March 9, 2012

FOOD STOREROOM BUILDING RENOVATIONS at ARUBA SURF CLUB

ADDENDUM NO. 3 (Post Bid VE)

FLOOR PLAN
 POWER

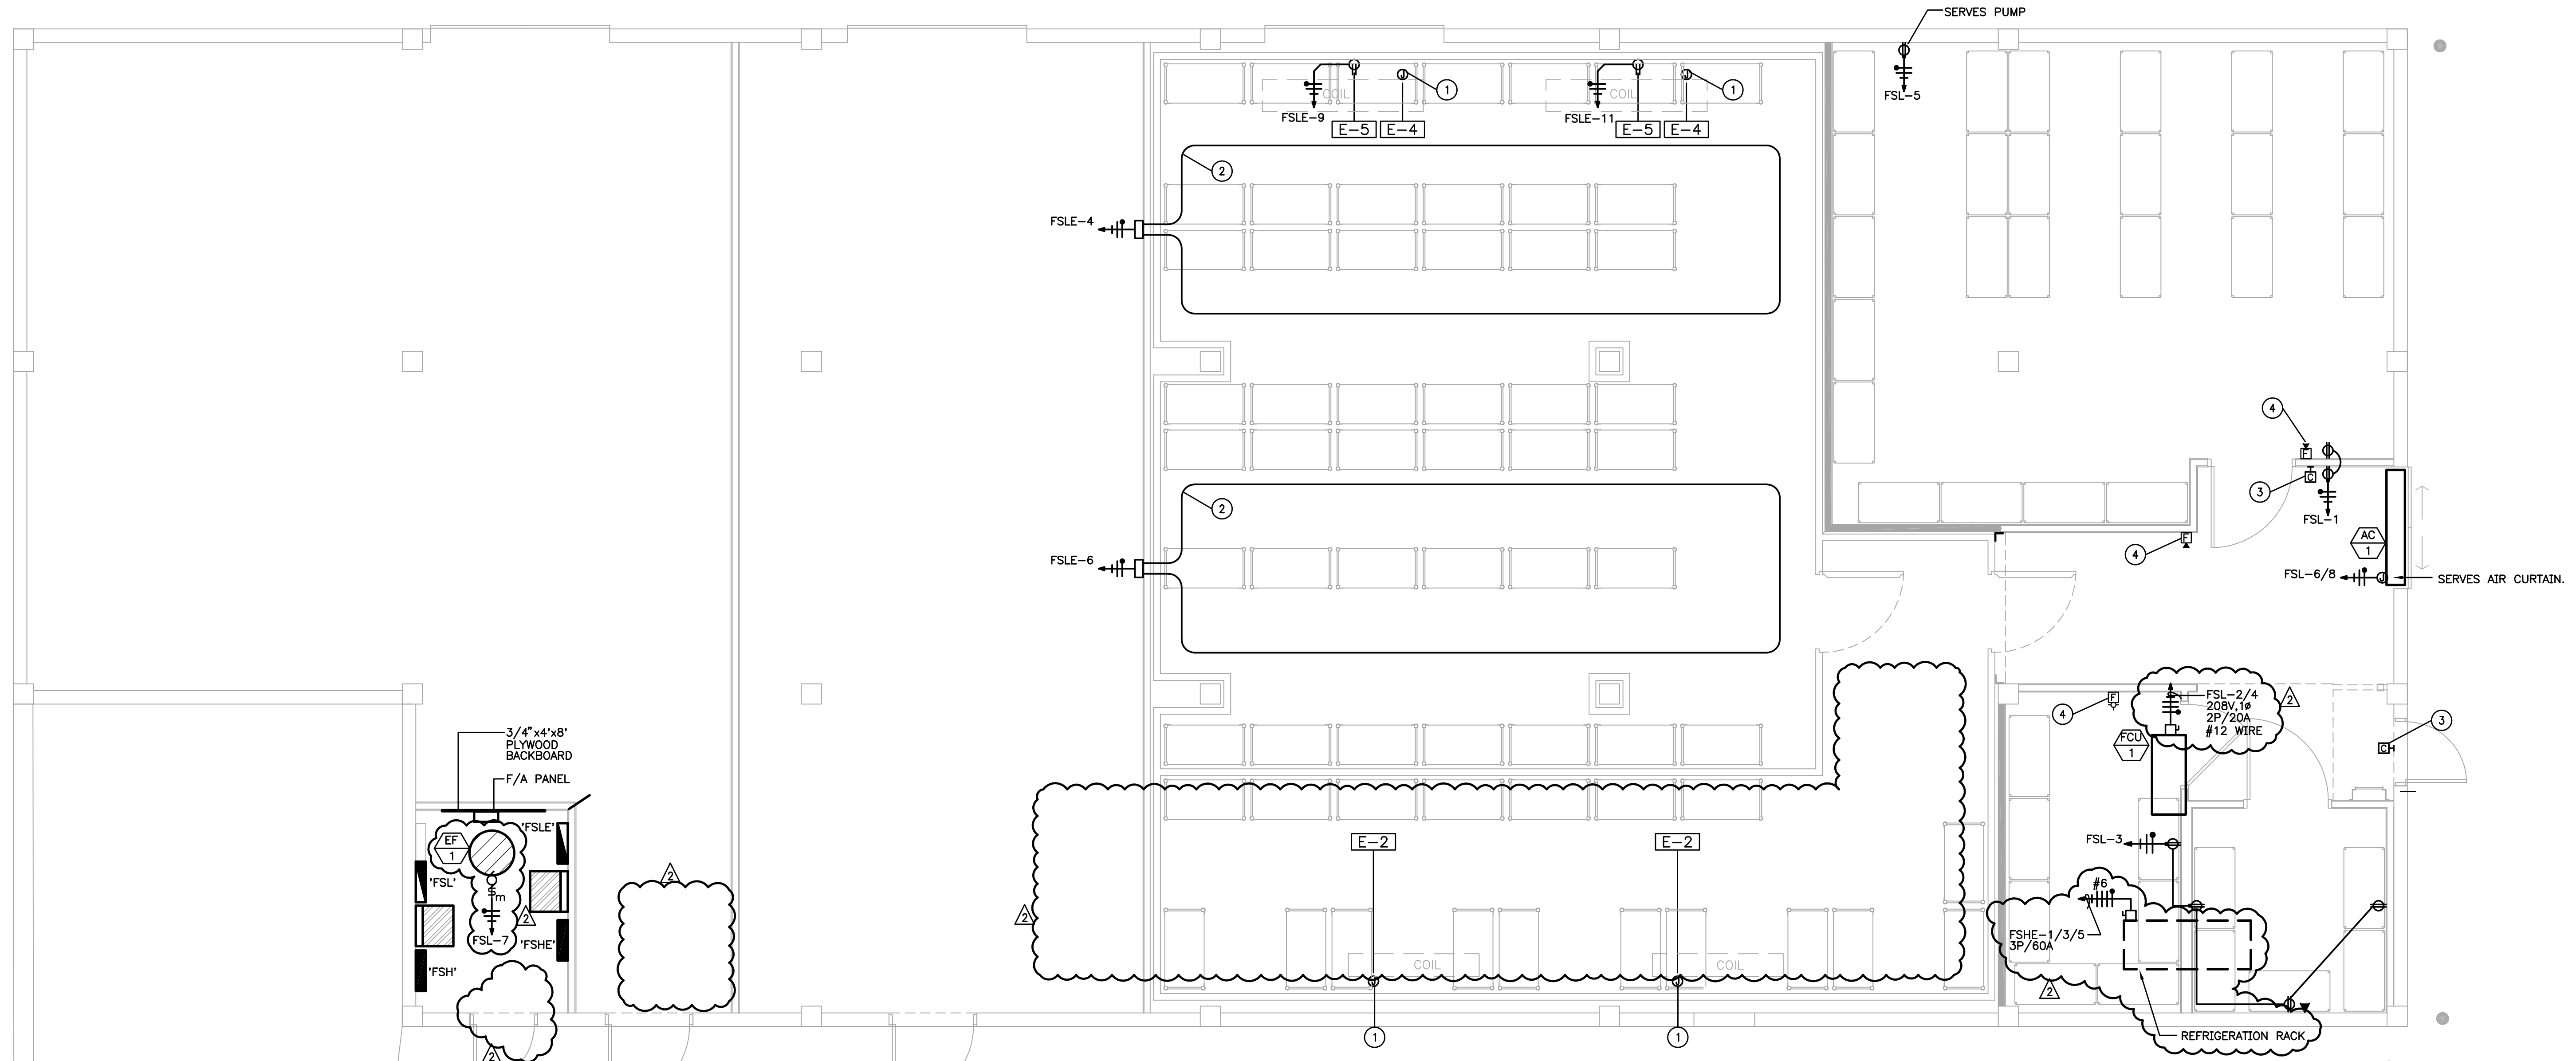
Sheet E2.0 - The following are VE modifications. . See revised E2.0 sheet.

- Delete power the FCU1 in electrical room.
- Add power to new roof mounted exhaust fan.
- Delete power to CU1 located in Engineering.
- Delete heat trace loop under cooler floor.
- Modify circuiting as indicated for new air cooled HVAC & refrigeration equipment.

FLOOR PLAN
LIGHTING

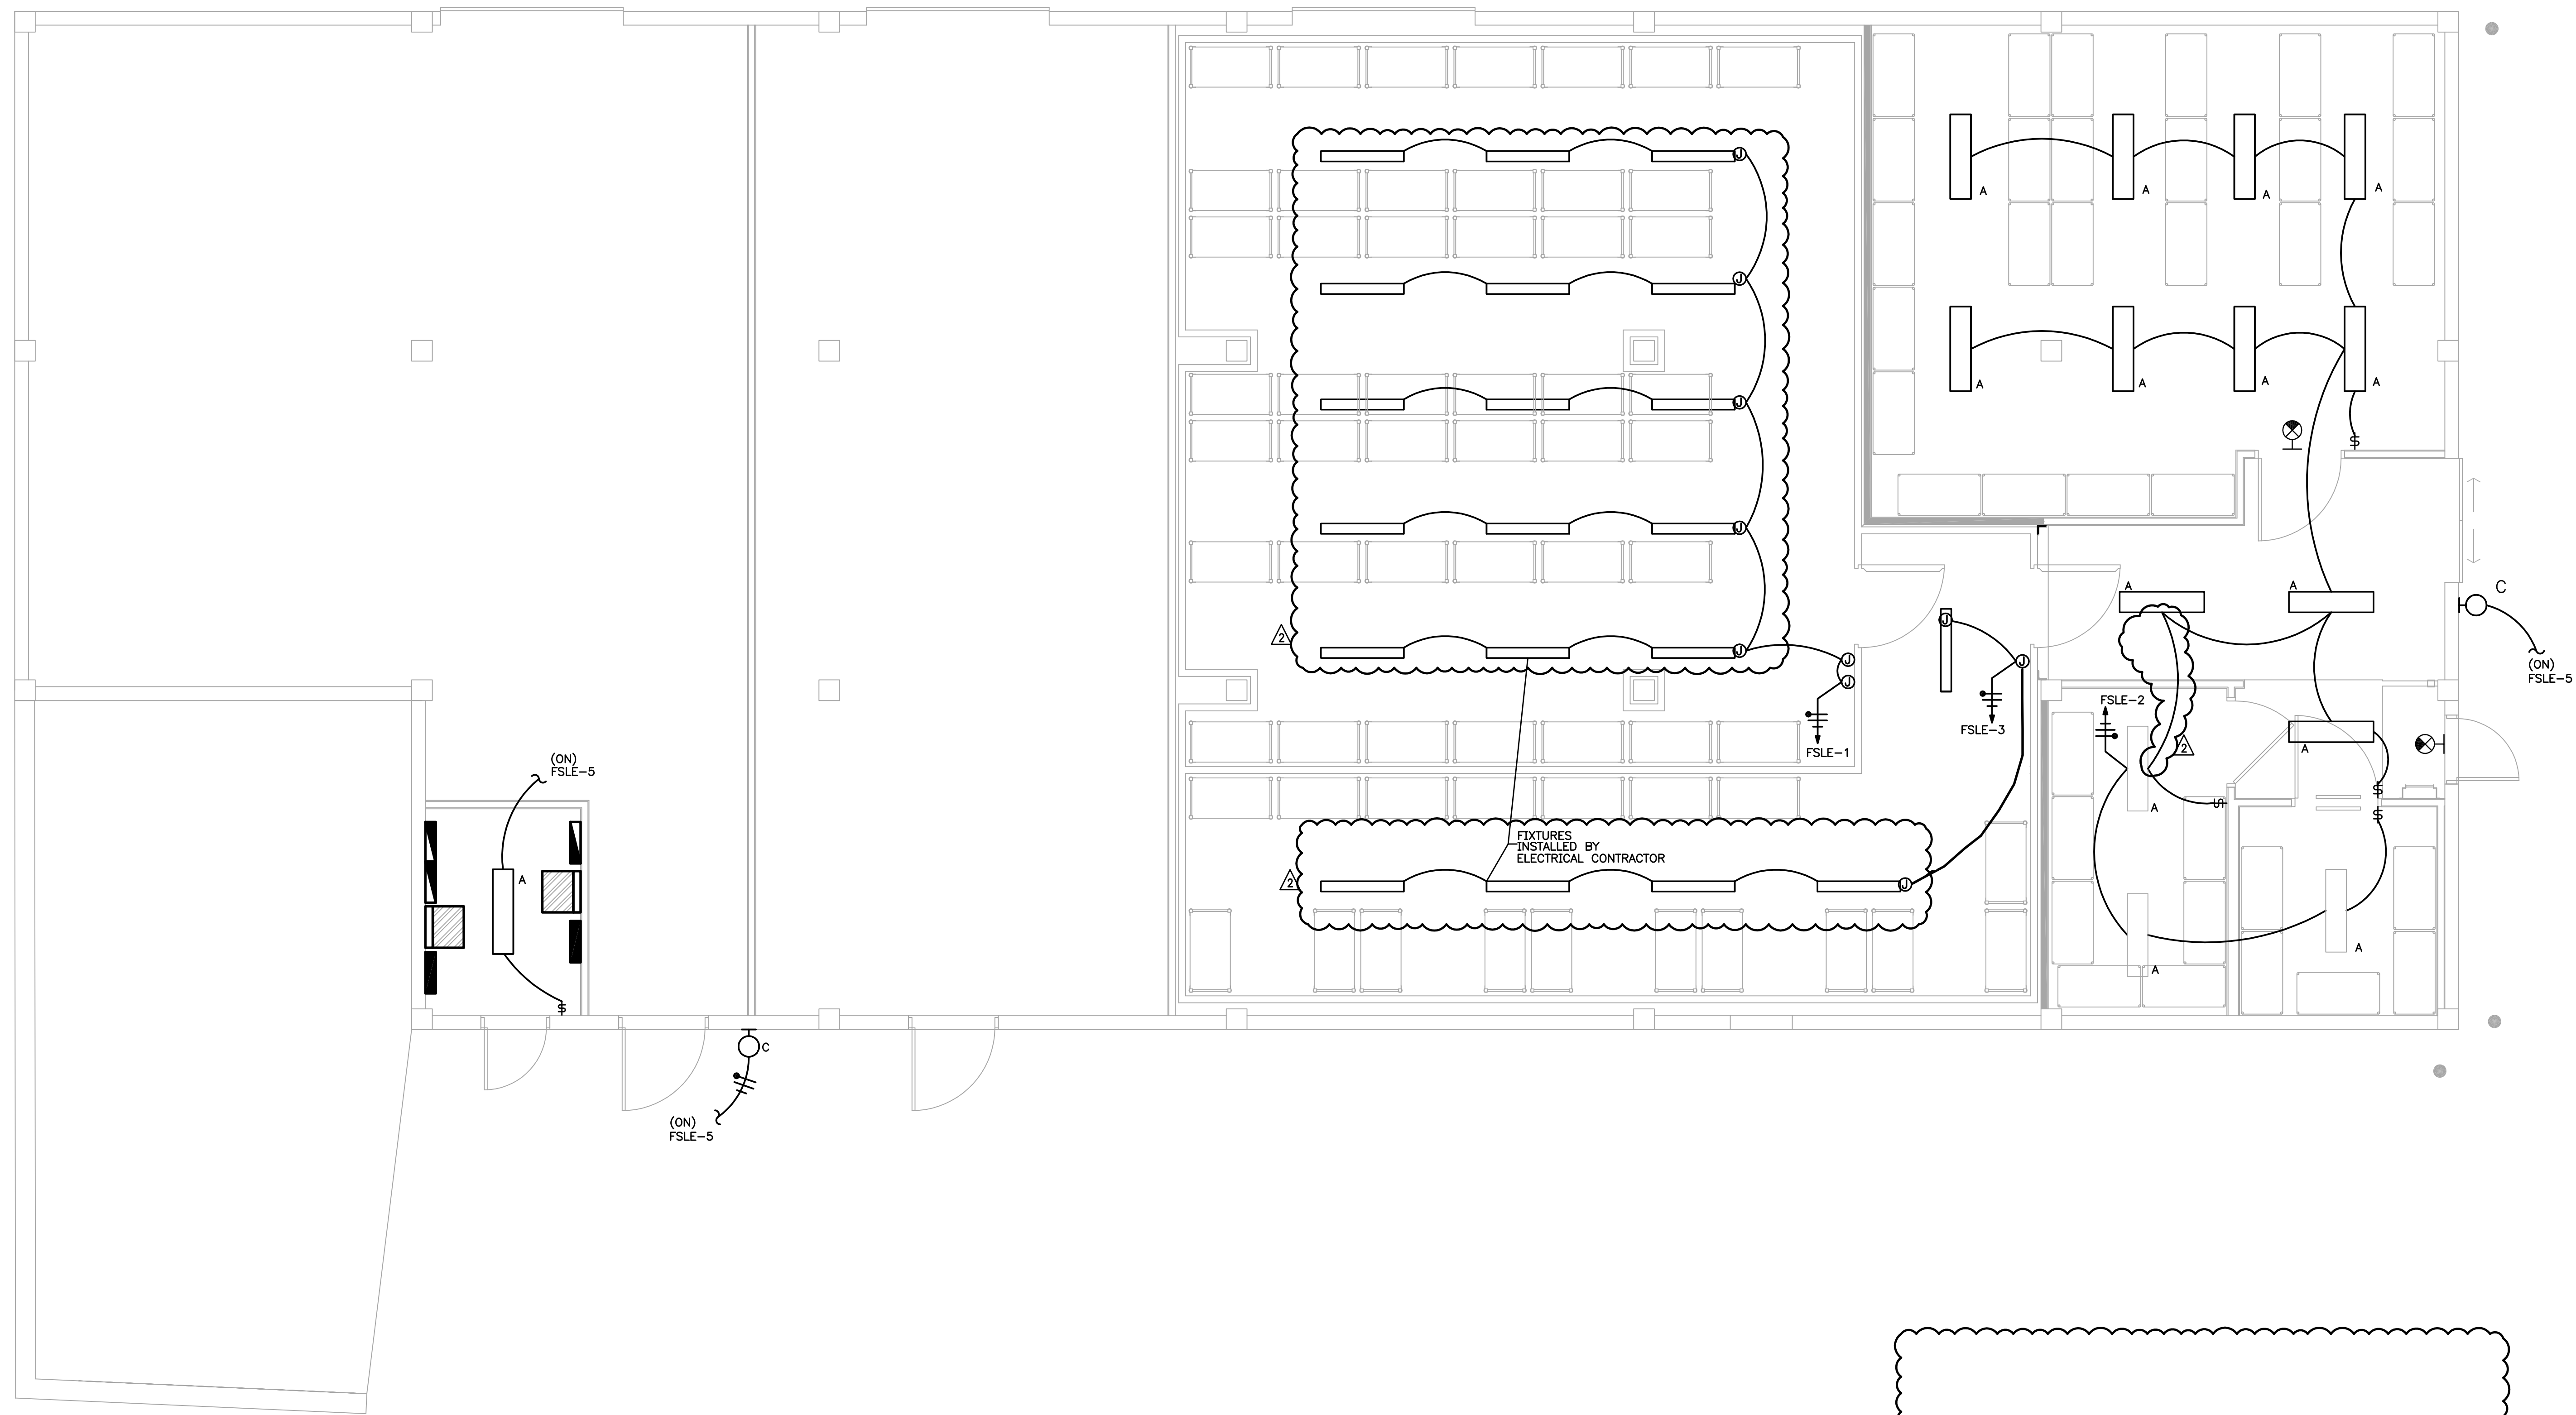
Sheet E3.0 - The following are VE modifications. . See revised E3.0 sheet.

- Delete lighting at the mezzanine.
- The number of lights in the cooler/freezer has been revised.
